Marked up version of changes to specification:

Amendments to the Drawings:

Remarks/Arguments:

FIG. 8 ~~22~~

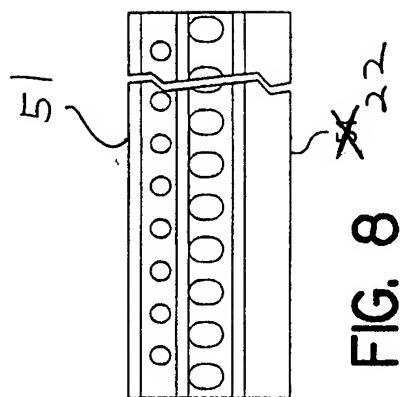
The Examiner objected to the drawings as failing to comply with 37 CFR 1.84(p)(4) because reference characters “22” and “51” have both been used to designate the counterweight guide rail in Fig. 8. In the present amendment, Fig. 8 has been amended to properly correct element numbering with respect to reference characters 22 and 51. Additionally, the Examiner has noted that reference character “87” has been used to designate both lower bolsters and counter weight assembly. Accordingly, in the present amendment, Applicant has amended Figs. 14 and 15 to show the counterweight assembly with reference character “91”. Finally, Fig. 15 that was originally filed has been amended to include element numbering. Also, a complete set of drawings is included with the present Amendment to replace originally filed drawing sheets 1-10 with replacement drawing sheets 1-10 that eliminate the hand-written element numbering.

By the present amendment, and as described in more detail in the Remarks Section of this Amendment, Figs. 8, 14 and 15 (or sheets 4/10, 9/10 and 10/10) are amended to correct element numbering of certain features of the invention. Attached as an Appendix to this paper is a complete set of Replacement Sheets (1/10 – 10/10) showing these changes as well as replacing drawing sheets originally filed with hand-numbered elements.

FIG. 14

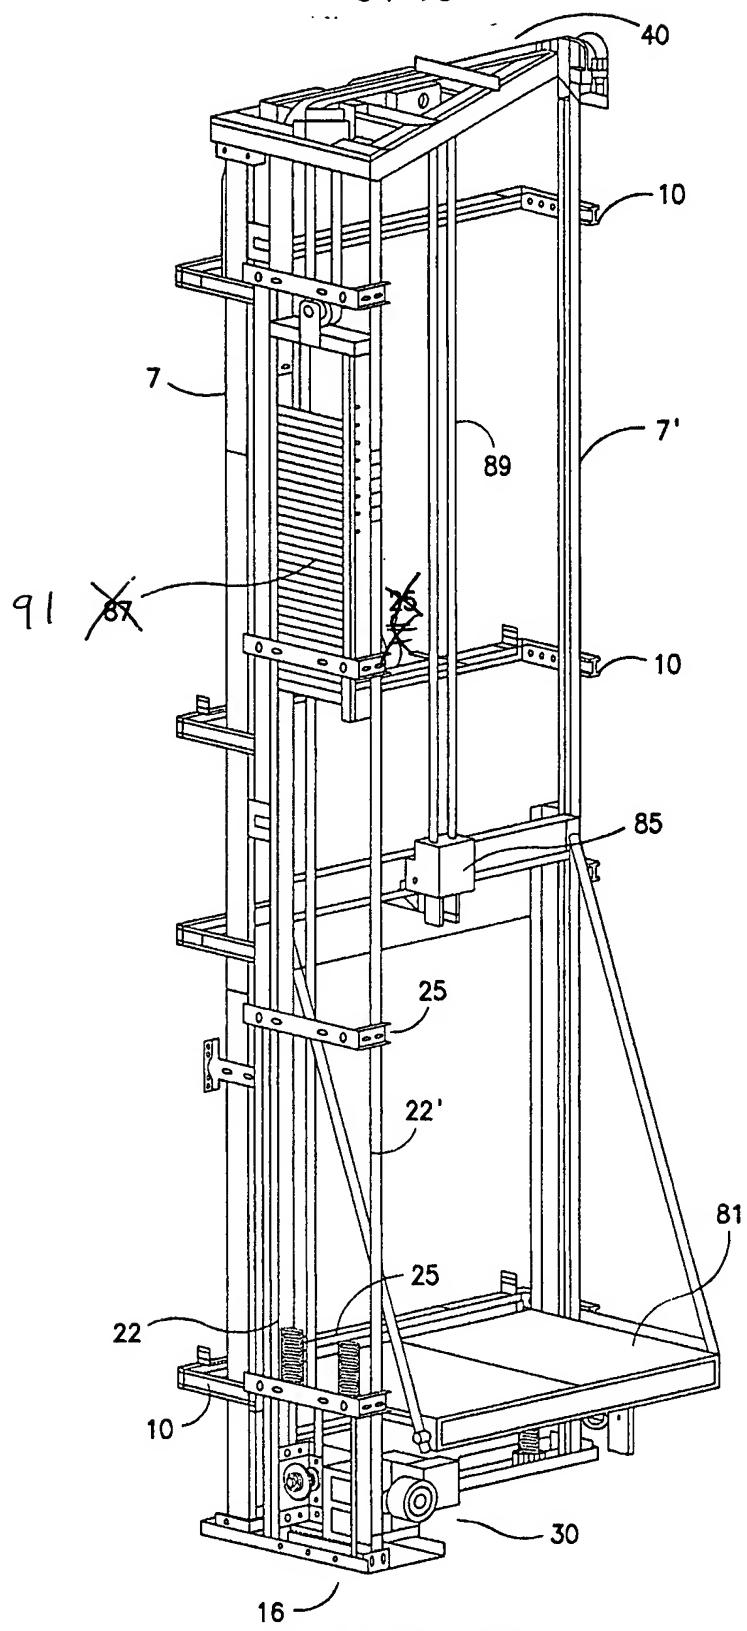
The Examiner has objected that reference characters “30” and “31” have both been used to designate the motor drive in paragraph [0045], lines 8-9 and in paragraph [0046], lines 12-13. The Examiner also notes that reference character “87” has been used to designate both the lower bolsters and the counterweight assembly. By the present Amendment, new paragraphs [0045], [0048]-[0050] are presented. Amendments to these paragraphs do not introduce any new matter; only corrections to the element numbering discrepancies identified by the Examiner have been made. Specifically, in paragraph [0045], the motor drive has been properly designated as element “31”. In addition, in paragraphs [0048]-[0050], the counter weight assembly is now designated with element number “91”.

[0048] As seen in FIGS. 14 and 15, the header module 40 affixed to the top of the support structure generally comprises one or more suspension sheaves, and the support rope 89 passes over the suspension sheave(s) to support the elevator car assembly 81 and the counterweight assembly 87-91. The rope 89 is driven by the motor drive 31 to move the elevator car assembly 81 and the counterweight assembly 87-91 within the hoistway.

[0049] In FIGS. 14 and 15, the elevator car assembly is mounted to slide along the car guide rails and has a front portion with guide shoes slidably coupled to the car guide rails 7 and 7'. Similarly, the counterweight assembly 87-91 is mounted to slide along the counterweight guide rails 22 and 22' and has guide shoes slidably coupled to the counterweight guide rails 22 and 22'. The elevator car assembly 81 can be of a car sling type. The elevator car assembly 81 can comprise a pick-up point assembly 85 located above the center of mass of the elevator car assembly 81 for engagement with the support rope 89. The pick-up assembly 85 may comprise a sheave for engagement with the support rope 89.
